INDESIT company

Model type:
MTAA242HA

Commercial code:
F058561

5172080 Exploded views

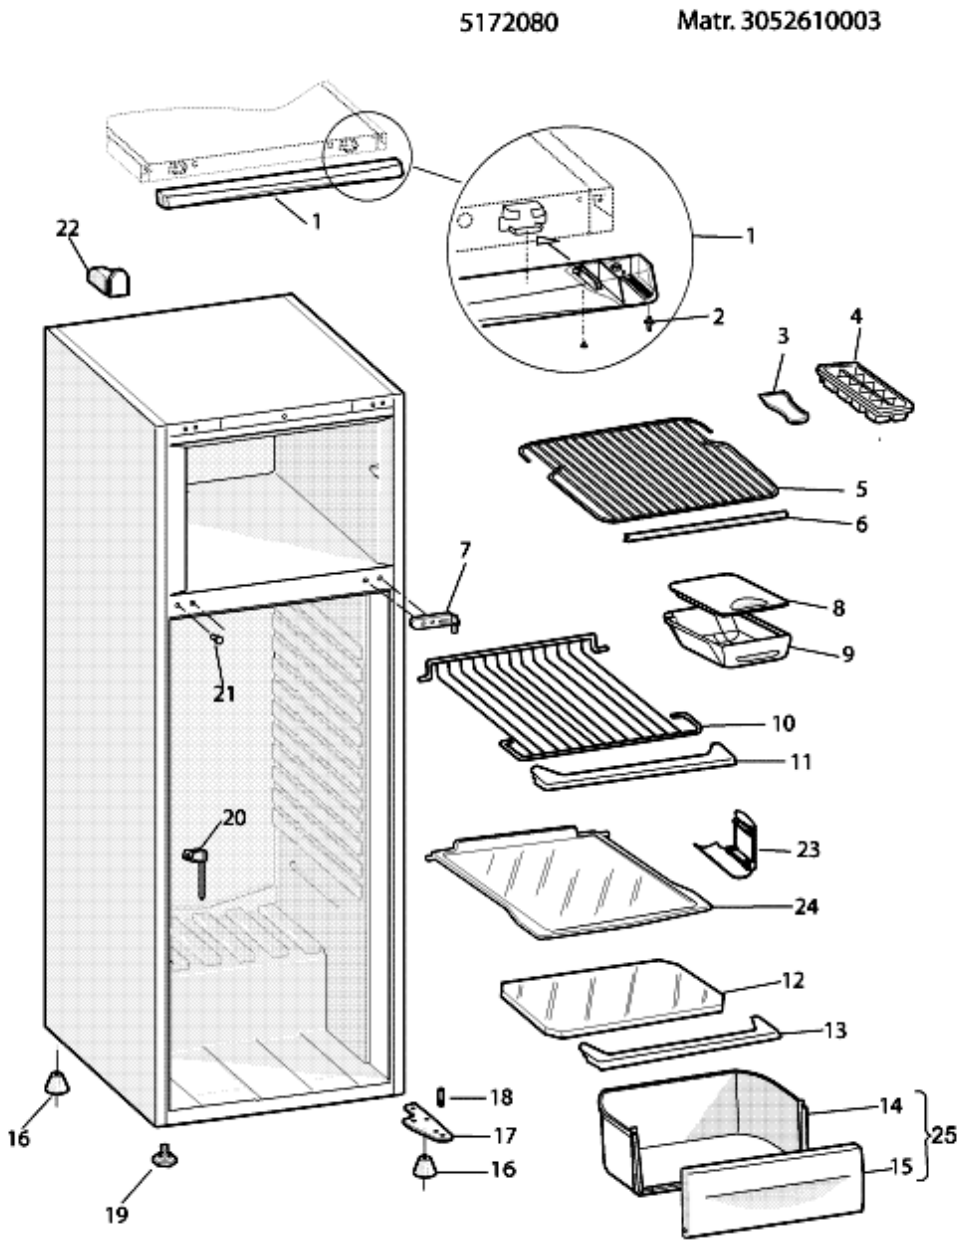
Ice tray has been standardized in order to manage only 12cubes version.

5172170 Exploded views

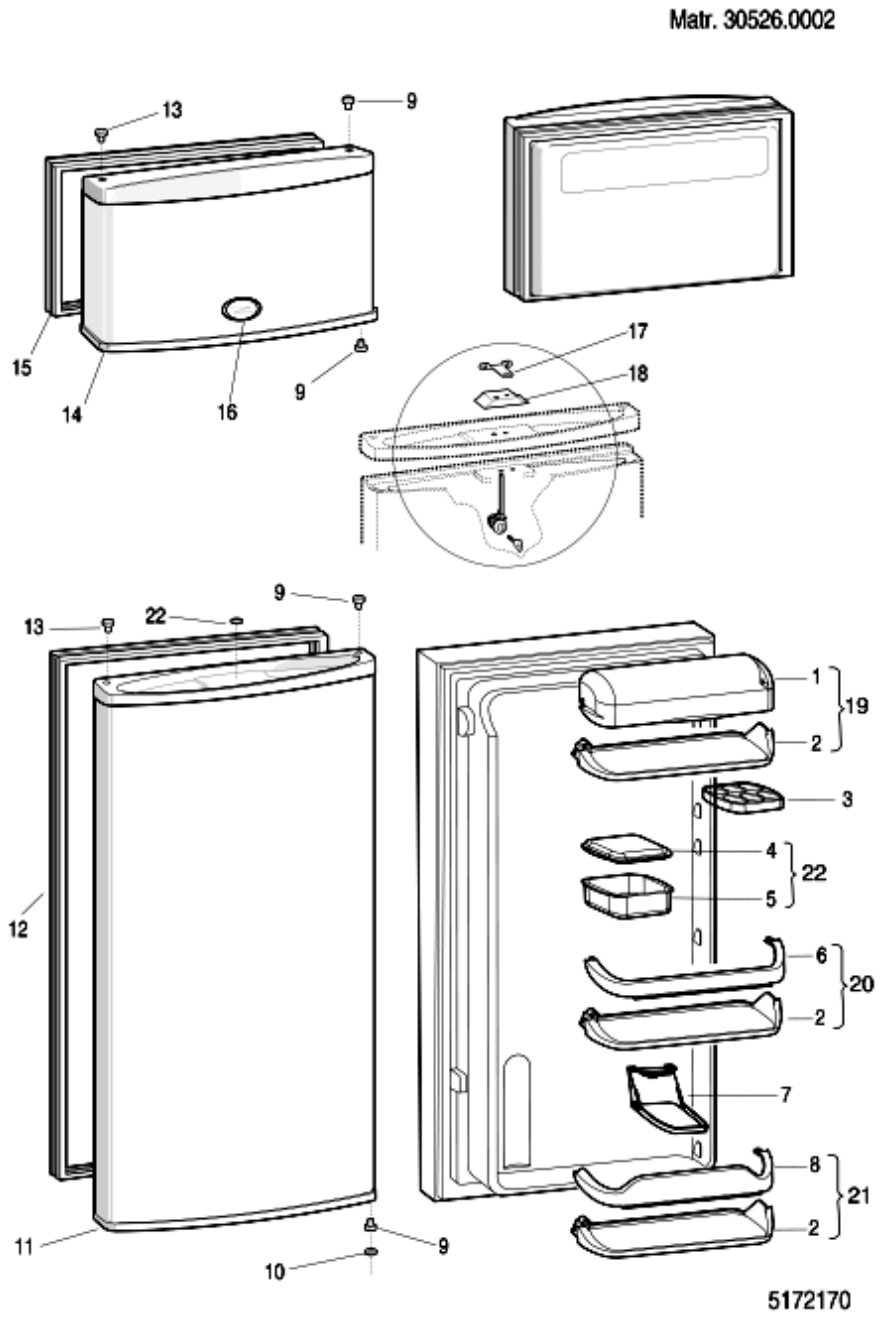
The colour of some of the internal shelves and accessories have changed to transparent. This affects models produced in Carinaro-Manisa. Modification is functionally interchangeable therefore once the colour versions of the parts have depleted they will automatically substitute to its corresponding transparent parts. Some parts will have been made obsolete with no substitution.

Some parts have changed from Satin Finish to Shiny (Crystal) Finish. These parts include;
-Door Shelves
-Crisper Front Panels

-Freezer Drawer Front Panels
All pre-modification components will be managed till the end of stock and after they will be substituted with new version.

5212250 Exploded views

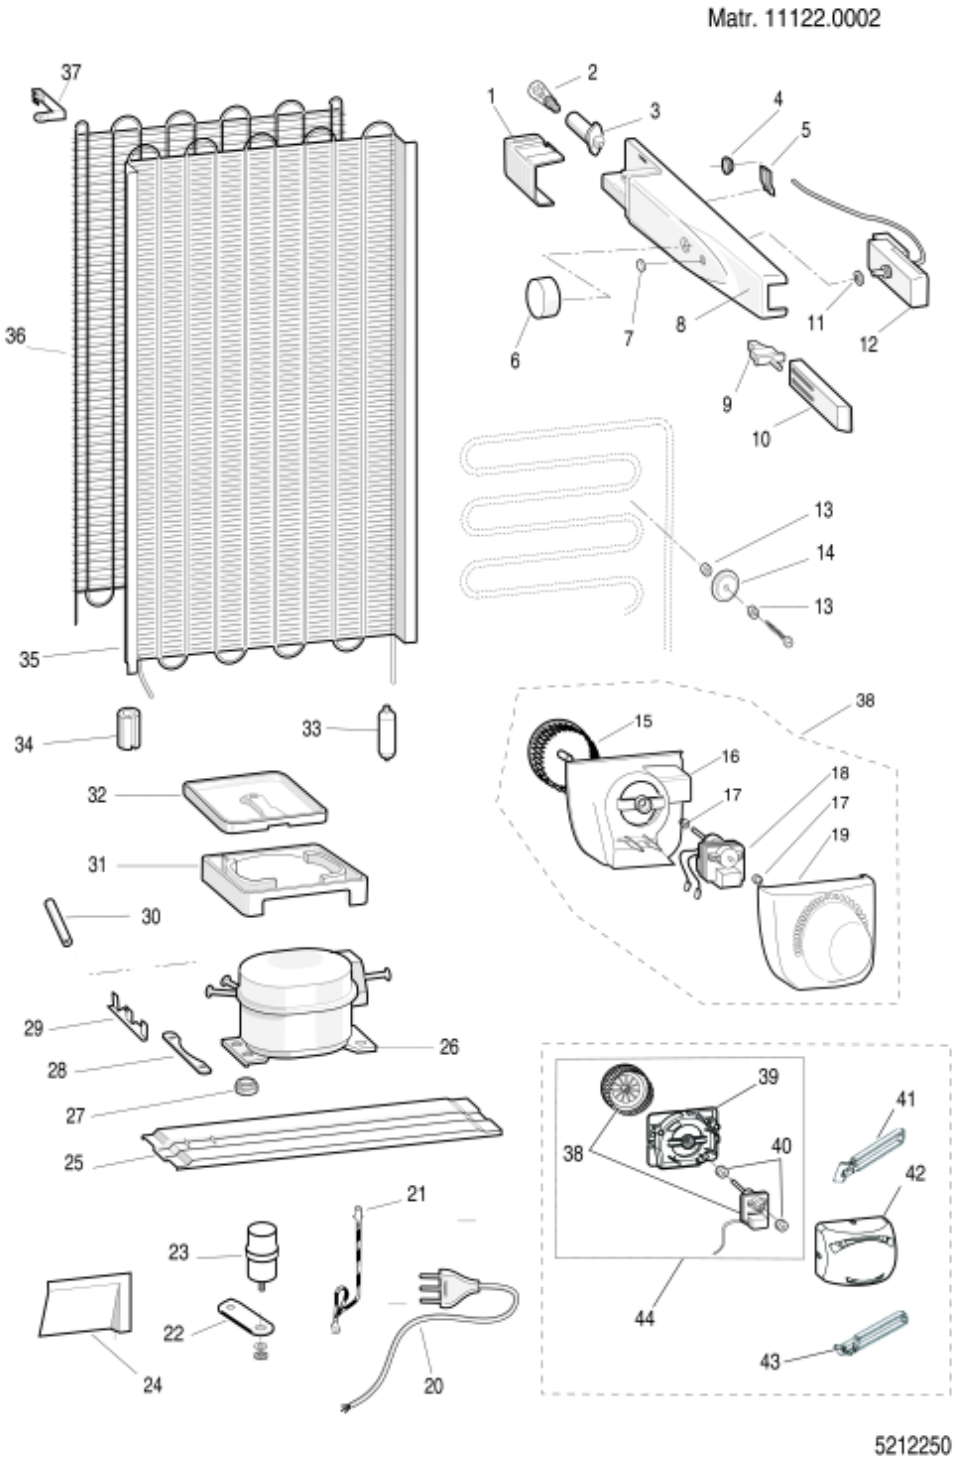
As of February-2001 (serial no. 10201.0001), the "thermostat box KIT for low ambient temperatures" is being handled with part number 076283 and is to be used on Indesit brand double-door refrigerators that have the Giugiaro thermostat box fitted on them

(048503 - 066297).
The kit should be used exclusively to solve those problems obtained due to the poor performance of the freezer due to an ambient temperature below +16°C.
The kit is innovative, as it has a 6.6 Watt resistance fitted inside the thermostat box that should be activated by the toggle switch with a rubber protection situated underneath the thermostat knob. The switch is activated when the ambient temperature drops below +13°C (contacts closed. See the wiring diagram included in the kit).
This resistance heats up and enables the thermostat to be reactivated, thereby allowing the appliance to operate correctly.
On the thermostat box, the resistance is glued onto an aluminium plate (152x42) itself glued to the box.
When replacing the thermostat box, no components should be re-used, and this includes the wiring.
The wiring in the kit has terminals with fastons for connecting them to the compressor's terminal board; in the event of different solutions, then make the suitable adjustments as necessary.

Moreover, the thermostat box in the kit was obtained from the Giugiaro one (066229) with the Vossloh lamp holder and the Eltek switch. On this box, the position of the fixing hole was moved 15 mm up; therefore, on the models that are fitted with the Giugiaro thermostat box (048503), the hole on the cabinet should be remade before mounting the kit.
Moreover, on the models that use the hidden bulb thermostats, the position of the mark should be remade on the thermostat in the kit and, if necessary, the sheath protecting the bulb should be removed.

0521123: SEALS FOR DOORS FOAMED AS ONE PIECE

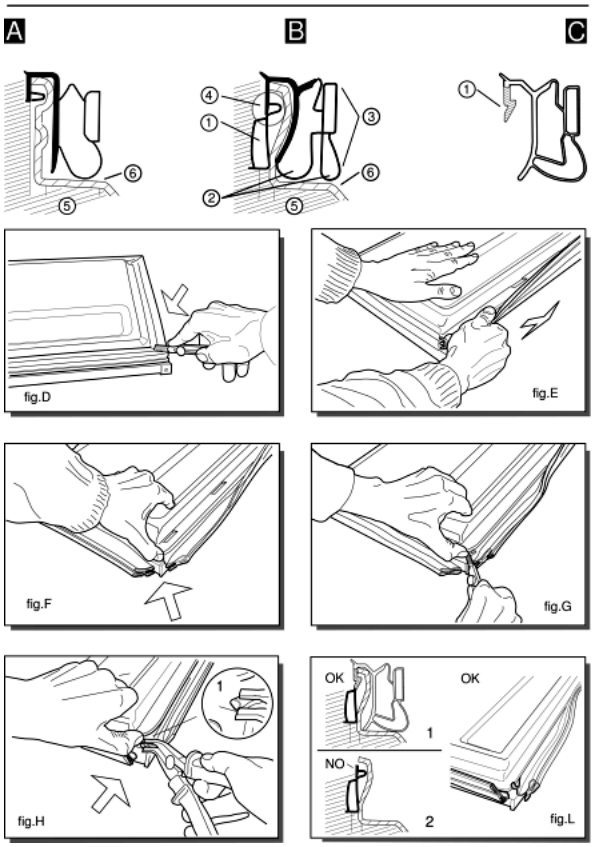
Various types of gaskets with different profile, as shown in figures (A) and (B), are used to fix the door (fig. A-5; B-5) and the inner door (fig. A-6; B-6) on the block foamed doors of combined freezers and refrigerators.
---Ilpea profile 245; 179; 412 (fig.A)
---Ilpea profile 287 (fig.B)
When replacing gaskets with profiles 245; 179; 412 these are fixed with screws (2 per corner) to the door.
Gaskets with profile 287 can not be used as spare parts but are designed to house the Ilpea type 900 gaskets (see figure C).
When replacing the gasket (287), once it is removed you will find a pocket (fig. B-1) between the door and inner door.
The rigid tooth (fig.C-1) of the gasket (900) is inserted inside between the pocket and the inner door, doing away with the need for screws.
Gasket with profile 287 is easy to identify since it has an exterior double edge (fig.B-2) which acts as a cushion when the door is closed.

To replace this gasket, follow these steps:
---Dismount the door and cut the four corners of the gasket along the joint (fig.D);
---lift the gasket and pull it carefully along its full length without tearing it (fig.E).
The purpose here is to detach the inner door slightly from the foam along the exterior edge for a depth equal to that of the gasket (fig.B-3);
---lift the corner of the inner door slightly, prising it up with your thumb (fig.F). Do not use a tool which might break the inner door;
---continue cutting the gasket inside the inner door for about 6 mm (fig.G);
---push in the tip of the pliers (type USAG N131) and pull outwards until you see the top edge of the pocket (fig. B-4) which is empty (fig.H-1);
---if you carry out this operation correctly (fig.L) you will be able to pull off the top edge of the pocket for the full length of the door.
If the gasket tears before the top edge (fig. L-2) you should repeat this operation from the other corner of the door.

---once the gasket (287), has been removed the space above the pocket (fig. L-1) can house the rigid tooth (fig. C-1) of the gasket 900.
When you fit this gasket ensure that it lies flush against the edge for the full length of the door.
If the rigid tooth is difficult to fit, eliminate any residues of foam between the door and the inner door in the gasket area.
fig.5131549A
